## **IMMA proposal for amendments to the presentation on Change Index GRE 79-12-rev.1 (79<sup>th</sup> GRE, 24-27 April 2018, agenda item 4)**

# GRE Informal Working Group „Simplification of Regulation“

Grouped approval marking – multiple lamp (function) type approval

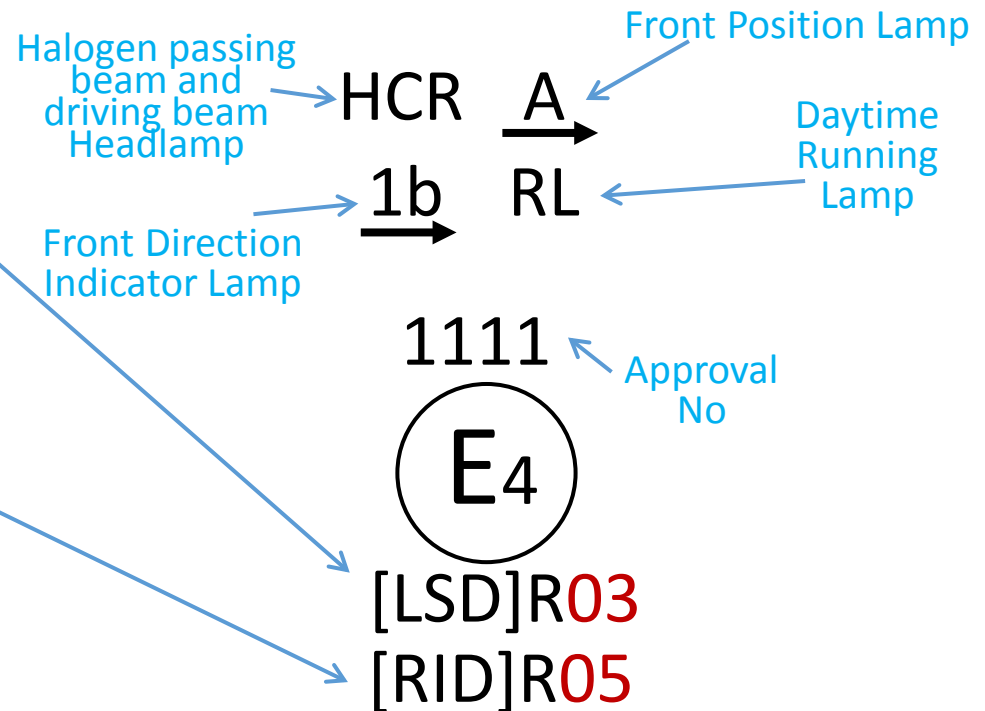
- 1) To add the sentence in blue to slide 7 of GRE-79-12-rev.1; see next slide at the bottom.
- 2) To move the whole presentation on Change Index to the Reference Material on the WP.29 website.

*The approval marking always shows the latest series of amendments of the Regulation applicable to the type approval of the specific lamp (function). This may not be the last series of amendments to the Regulation in force.*
